**Rezoning Transportation Analysis**  
**Petition Number: Insert Zoning Petition # 2021-007**  
*General Location Identifier: Tax ID 08113110*

Revision Log:	Date	Description
	03-25-2021	First Review (WB)

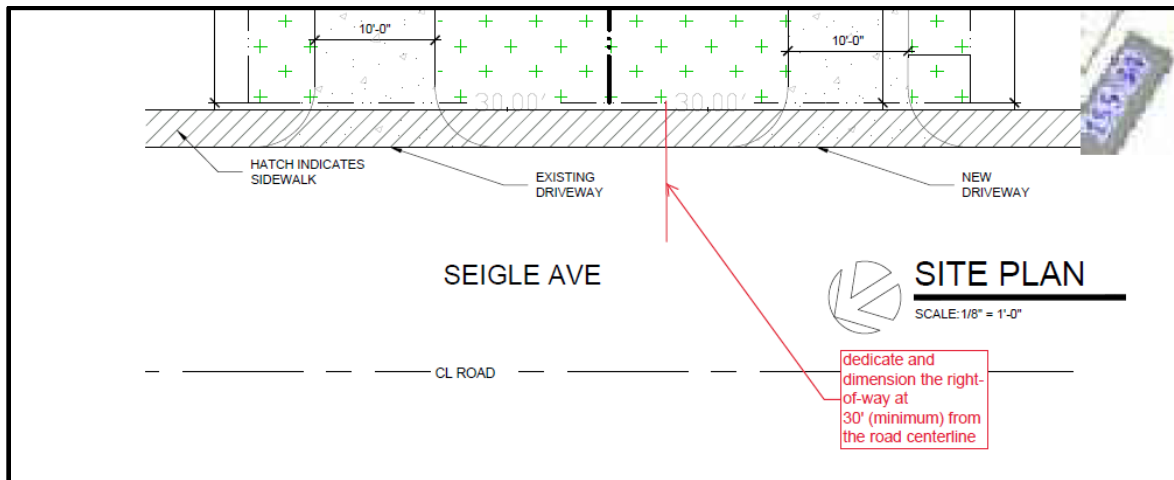
1. **Curblines:** The proposed zoning district has a setback measured from back of the existing or proposed future curblines.
  - a. **Seigle Avenue:** Location of curb and gutter needs to be constructed at 18.5' from the road centerline removing the existing on-street parking along the site's frontage.

Label and dimension the curb and gutter from the centerline for each road on the site plan.

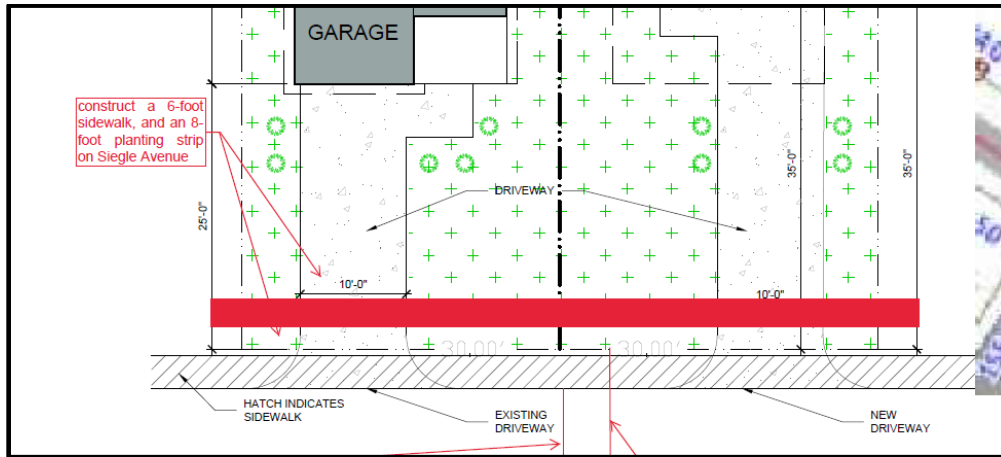
4. Revise site plan and conditional note(s) to commit to construct a 6-foot sidewalk, and an 8-foot planting strip on Seigle Avenue per Chapter 19. The site plan shall label and dimension both items from the back of curb and gutter and road centerline.

Reference CLDSM standard detail 11.09 for street typical.

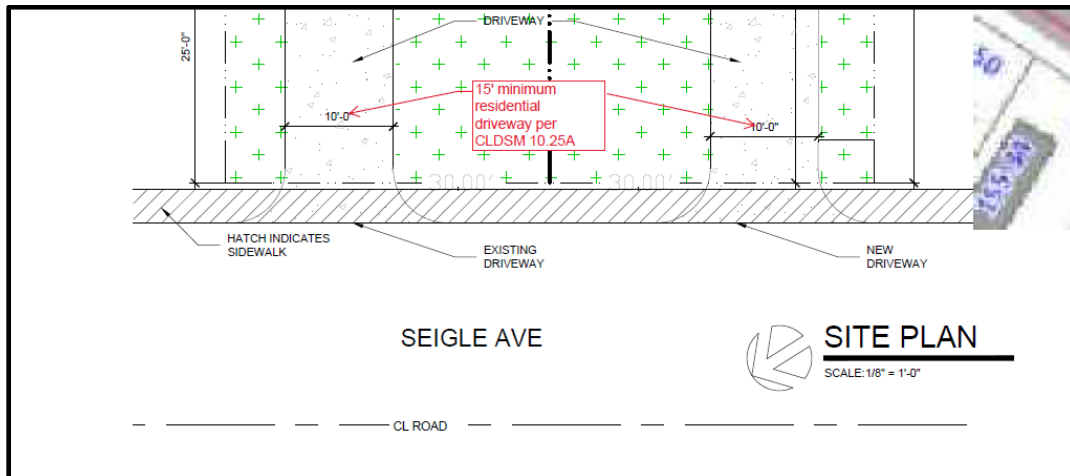
5. Site plan and conditional note(s) revisions are needed to commit to construct 15' minimum Residential driveways per CLDSM 10.25A.
